Changes to ARMER Conceptual Plan (February 2008)

Prepared by Mn/DOT Office of Electronic Communication

Inter Zone Links:

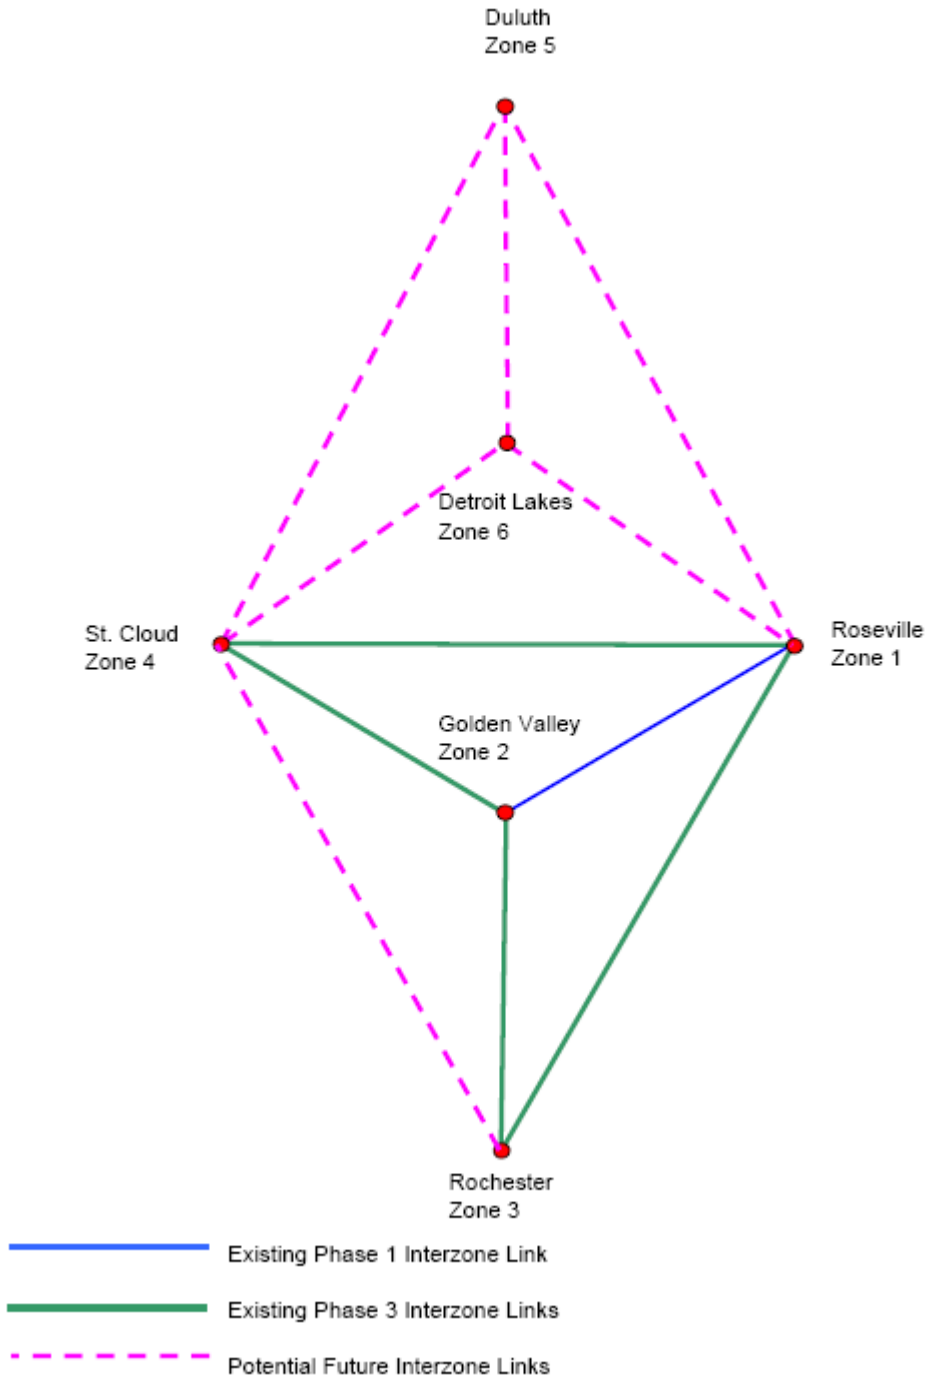
Previously proposed Inter-zone link plan:

New proposal for Inter-zone links:

In reviewing the conceptual plan, one zone controller was planned to cover two different geographically separated regions. The zone controller was planned to be located in Rochester. It would appear that not a lot of thought went into this part of the conceptual plan. We looked at the plan to tie all sites in St. Cloud to Rochester and determined that the microwave costs to do these links would approach the cost of an additional zone controller.

There are 26 sites plus the dispatch centers in the St Cloud area that need to be routed to the zone controller. Even if you pack the sites together to minimize the number of T1s we still need at least a 28T1 path from St Cloud to Rochester. A minimum of 10 hops of microwave would be needed to accomplish this. At \$300,000 per hop we are approaching \$3,000,000 just for this interconnection. The same problem exists if you were to move the ZC to St Cloud. We also looked at putting the zone controller half way between and locating it in the Metro. The same problem exists since now all Rochester and St Cloud sites need to be linked back to the metro.

The Statewide Radio Board has approved the addition of Zone 4 in Phase III.
